Elm Tree Farm, Sellindge

Transport Assessment Addendum

Road Safety Audit Stage 1

Designer's Response to the Stage 1 Safety Audit

Proposed Site Access

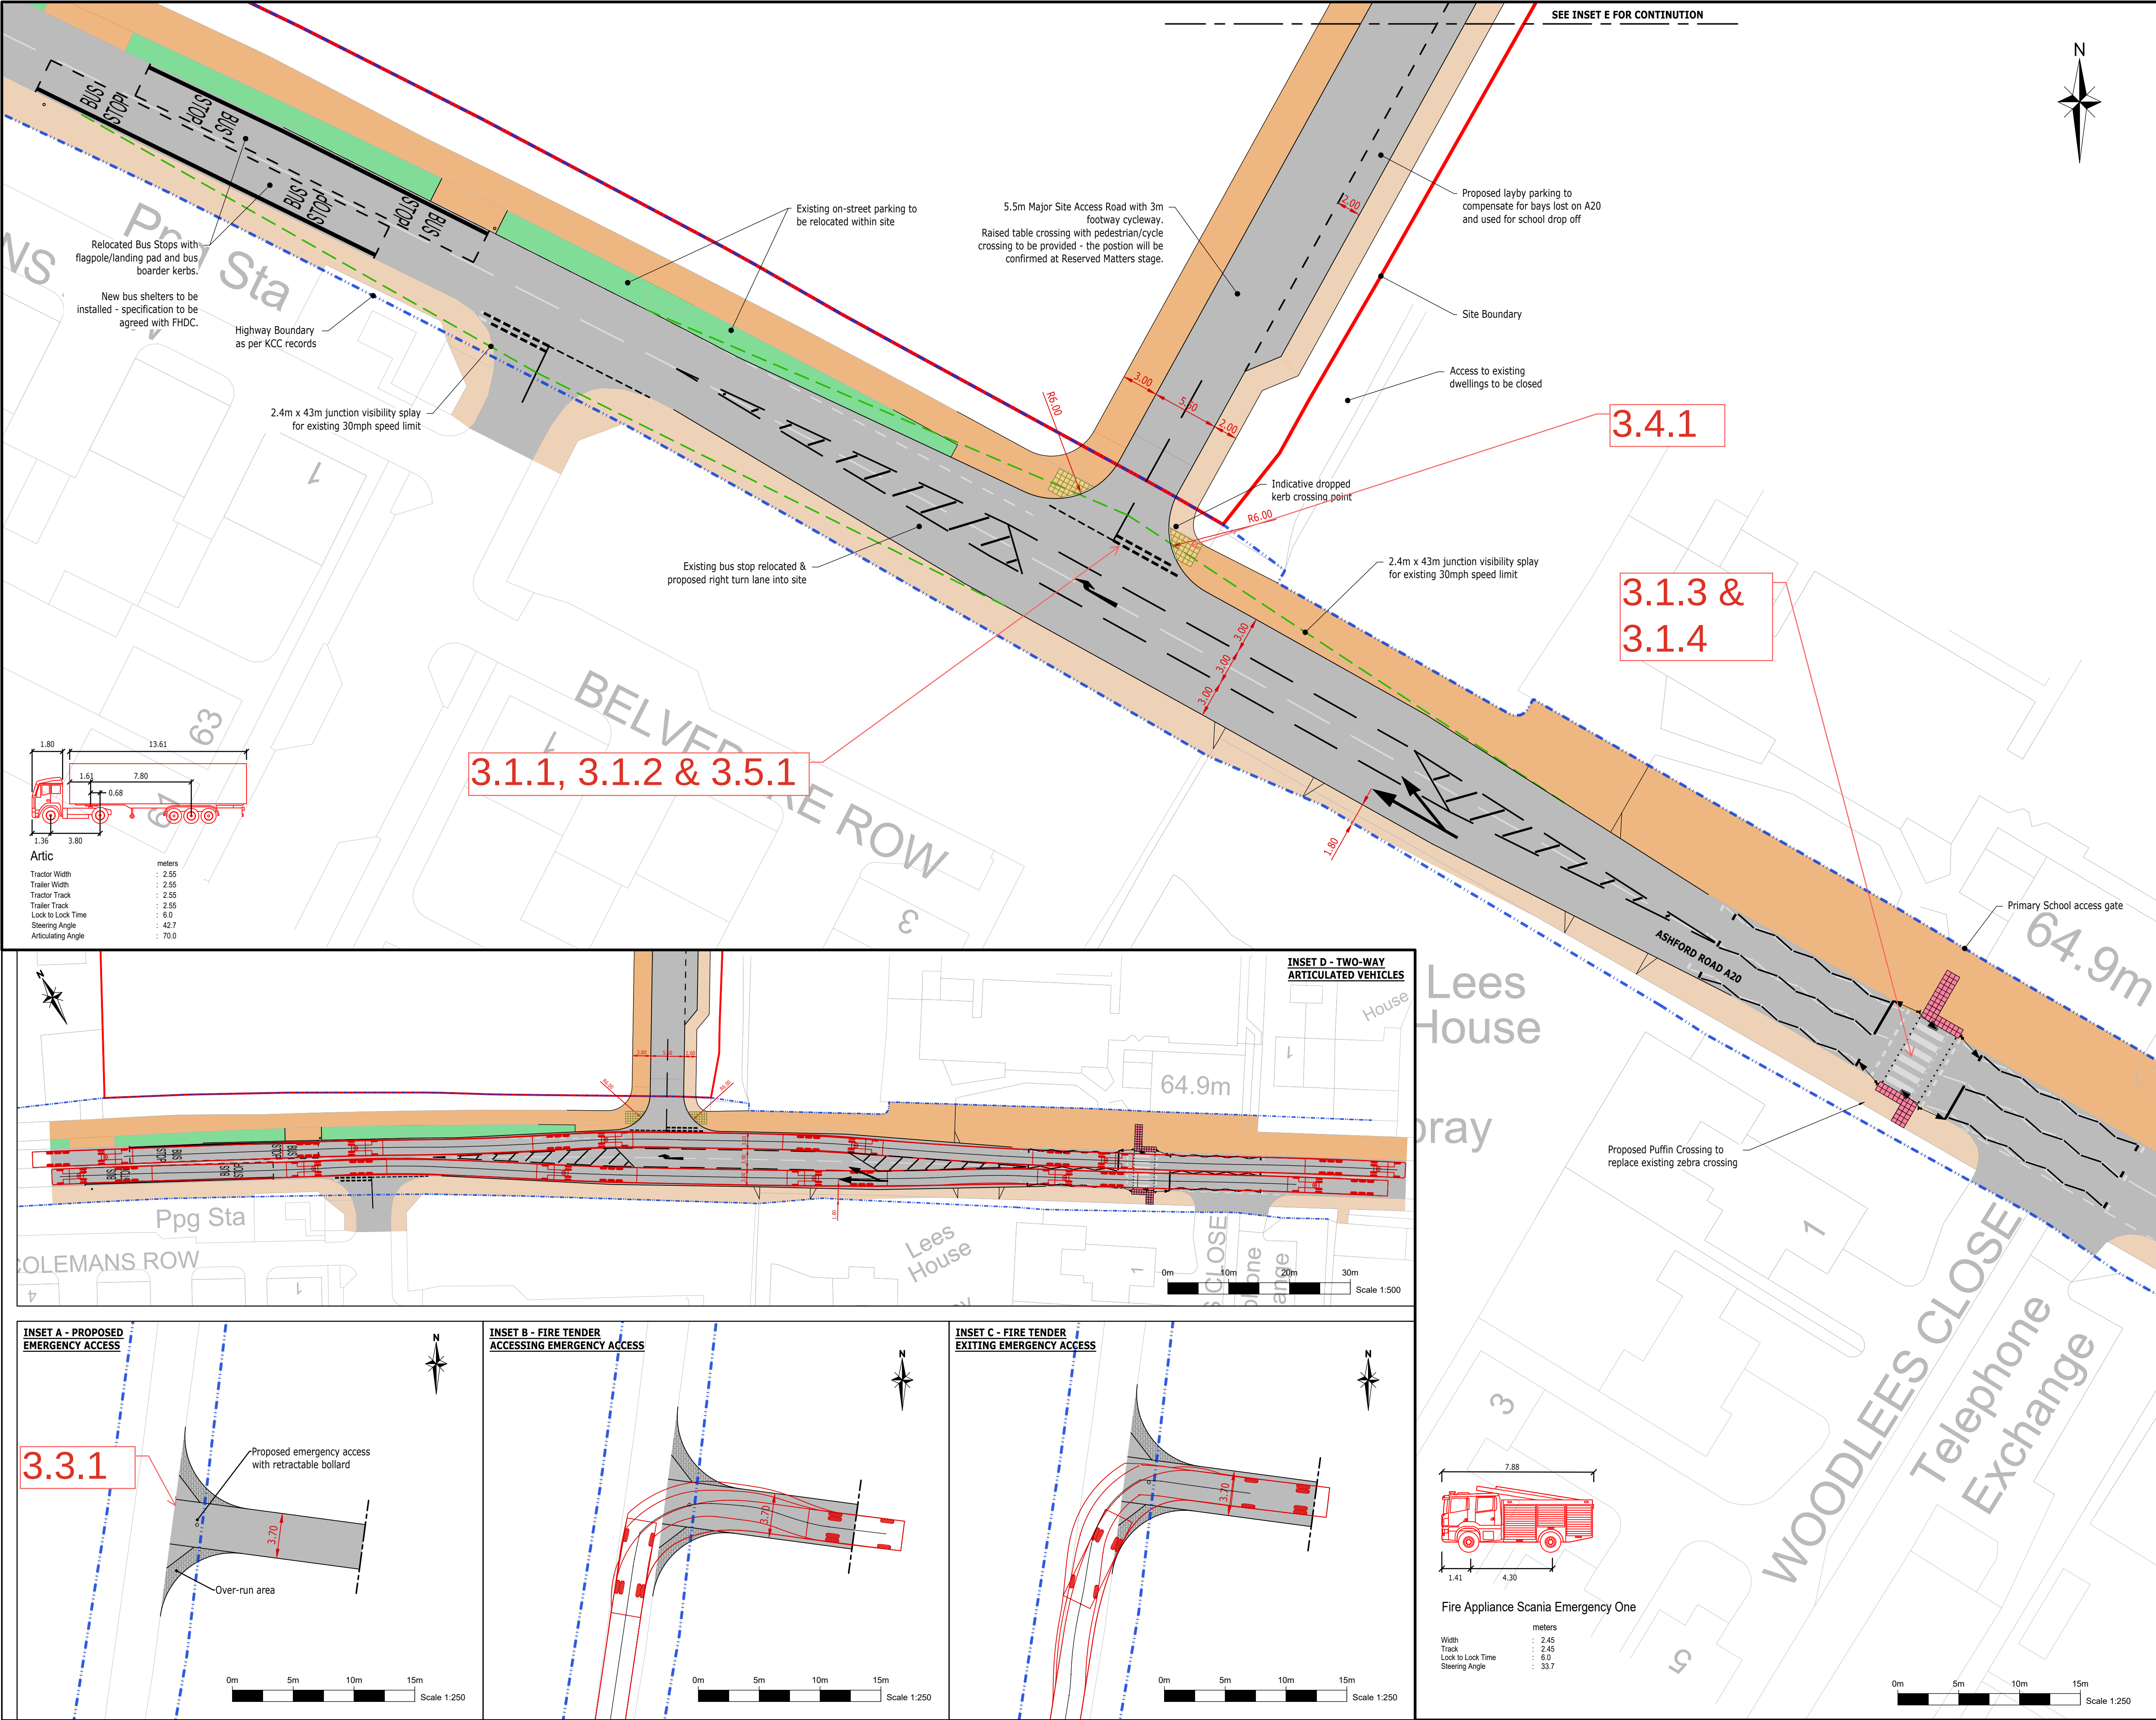
3.1.1 PROBLEM

Summary: Inappropriate surfacing could lead to loss of control collisions.

It is also noted that is proposed to widen the carriageway to accommodate the proposed right turn lane at the access, where vehicles may be straddling two different surface types and may experience differential braking, which under sudden severe braking conditions could lead to loss of control collisions.

3.1.2 PROBLEM

Summary: Ponding of surface water could lead to loss of control collisions.

It is proposed to widen sections of the carriageway to accommodate the right turn lane junction, where no details have been provided regarding the carriageway drainage at this early stage. Inadequate drainage provision could cause possible ponding, which could lead to loss of control collisions.

3.1.3 PROBLEM

Summary: Excessive speed on approaches to signals could lead to vehicle to pedestrian collisions or rear end shunt collisions.

No traffic survey information was provided for assessment and although this section of Ashford Road has a 30mph speed restriction the road has a straight alignment and observed free flow speeds were high. Excessive speeds on the approaches to the crossing may affect the safe

3.1.4 PROBLEM

Summary: Lack of maintenance provision could lead to side swipe collisions, rear end shunt or vehicle to pedestrian / cycle collisions.

No vehicle maintenance bay has been shown on the plan provided, where a lack of provision may result in operatives parking in unsafe locations. This could lead to restricted intervisibility increasing the risk of vehicle to pedestrian collisions or rear end shunts, in the event of sudden braking.

3.3.1 PROBLEM

Summary: Restricted visibility could increase the risk of side impact collisions.

No details relating to the visibility splays at the access have been provided for assessment. There is concern that hedgerows could restrict visibility where a lack of visibility could increase the risk of side impact collisions.

3.4.1 **PROBLEM**

Summary: Insufficient pedestrian / traffic intervisibility could lead to vehicle to pedestrian collisions.

There is concern that the parking bays on the eastern side of carriageway of the access road may restrict pedestrian / traffic intervisibility at the eastern corner of the junction. A parked vehicle in the bay could mask a child pedestrian at the crossing, where restricted intervisibility could lead to vehicle to pedestrian collisions.

3.5.1 **PROBLEM**

Summary: Insufficient road markings on approach to junction could lead to overshoot collisions.

At the junction with Ashford Road only three warning lines to diagram 1004 are proposed on the approach to the junction. Insufficient warning of the junction approach could lead overshoot collisions.

It is recommended that materials used in the carriageway construction be of a consistent PSV to those used throughout the junction.

It is recommended that drainage details and carriageway profiles be such that surface water is shed to an appropriate surface water system, where details should be supplied for assessment at Stage 2 Road Safety Audit.

It is recommended that the 85th percentile speeds be checked to see if speed discrimination or speed assessment equipment is required.

It is recommended that a vehicle maintenance bay should be provided at a location, which does not interfere with the visibility splays.

It is recommended that there should be no physical obstruction of the visibility splays and additionally, that the splays should be periodically maintained to retain visibility.

It is recommended that parking bays should not impede upon the pedestrian / traffic intervisibility splays at the crossing point.

It is recommended that the additional longitudinal markings should be installed in accordance with Table 5-1 of Traffic Signs Manual, Chapter 5, Road Markings.

Audit Team No.	Audit Team Observation	Audit Team Recommendation	C&A Designers Response	Client Comment
3.1 - General				
3.1.1	Location: Proposed junction. Summary: Inappropriate surfacing could lead to loss of control collisions. It is also noted that is proposed to widen the carriageway to accommodate the proposed right turn lane at the access, where vehicles may be straddling two different surface types and may experience differential braking, which under sudden severe braking conditions could lead to loss of control collisions.	Recommendation: It is recommended that materials used in the carriageway construction should be of a consistent PSV to those used throughout the junction.	Agree: Appropriate surfaces to be used.

3.1.2	Location: Proposed junction. Summary: Ponding of surface water could lead to loss of control collisions. It is proposed to widen sections of the carriageway to accommodate the right turn lane junction, where no details have been provided regarding the carriageway drainage at this early stage. Inadequate drainage provision could cause possible ponding, which could lead to loss of control collisions.	Recommendation: It is recommended that drainage details and carriageway profiles should be such that surface water is shed to an appropriate surface water system, where details should be supplied for assessment at Stage 2 Road Safety Audit.	Agree: Drainage details to be provided at stage 2.

3.1.3	Location: Proposed Puffin crossing. Summary: Excessive speed on approaches to signals could lead to vehicle to pedestrian collisions or rear end shunt collisions. No traffic survey information was provided for assessment and although this section of Ashford Road has a 30mph speed restriction the road has a straight alignment and observed free flow speeds were high. Excessive speeds on the approaches to the crossing may affect the safe operation of the crossing and could lead to vehicles not being able to stop, increasing the risk of vehicle to pedestrian collisions or rear end shunts, in the event of sudden braking.	Recommendation: It is recommended that the 85th percentile speeds be checked to see if speed discrimination or speed assessment equipment is required.	Disagree: Vehicles approaching the crossing have clear visibility of the proposed crossing. The surrounding area is a residential area with zebra crossings and an existing speed limit of 30mph - it is not expected that vehicles will be exceeding the speed limit in this location. The existing zebra crossing has anti-skid surfacing, this could be extended as a precaution.

3.1.4	Location: Proposed Puffin crossing. Summary: Lack of maintenance provision could lead to side swipe collisions, rear end shunt or vehicle to pedestrian / cycle collisions. No vehicle maintenance bay has been shown on the plan provided, where a lack of provision may result in operatives parking in unsafe locations. This could lead to restricted intervisibility increasing the risk of vehicle to pedestrian collisions or rear end shunts, in the event of sudden braking.	Recommendation: It is recommended that a vehicle maintenance bay should be provided at a location, which does not interfere with the visibility splays.	Agree: Maintenance vehicles to utilise parallel parking bays when carrying out maintenance to signals.

3.3.1	Location: Proposed emergency access. Summary: Restricted visibility could increase the risk of side impact collisions. No details relating to the visibility splays at the access have been provided for assessment. There is concern that hedgerows could restrict visibility where a lack of visibility could increase the risk of side impact collisions.	Recommendation: It is recommended that there should be no physical obstruction of the visibility splays and additionally, that the splays should be periodically maintained to retain visibility.	Agree: 43m Visibility splays added for existing speed limit of 30mph. Land within visibility splays to be kept clear and maintained. See revised drawing 20-029-001_Rev G for details

3.4 - Non-Motorised User (NMU) Provision				
3.4.1	Location: Proposed junction. Summary: Insufficient pedestrian / traffic intervisibility could lead to vehicle to pedestrian collisions. There is concern that the parking bays on the eastern side of carriageway of the access road may restrict pedestrian / traffic intervisibility at the eastern corner of the junction. A parked vehicle in the bay could mask a child pedestrian at the crossing, where restricted intervisibility could lead to vehicle to pedestrian collisions.	Recommendation: It is recommended that parking bays should not impede upon the pedestrian / traffic intervisibility splays at the crossing point.	Agree: Parallel parking bays shifted further to avoid potential interaction with pedestrian crossing. drawing 20-029-001_Rev G.

3.5 – Road Signs, Carriageway, Markings and Lighting				
3.5.1	Location: Proposed junction. Summary: Insufficient road markings on approach to junction could lead to overshoot collisions.	Recommendation: It is recommended that the additional longitudinal markings should be installed in accordance with Table 5-1 of Traffic Signs Manual, Chapter 5, Road Markings.	Agree: Centreline markings extended as per TSM Chapter 5 Table 5-1 for vehicle speeds <30mph. drawing 20-029-001_Rev G
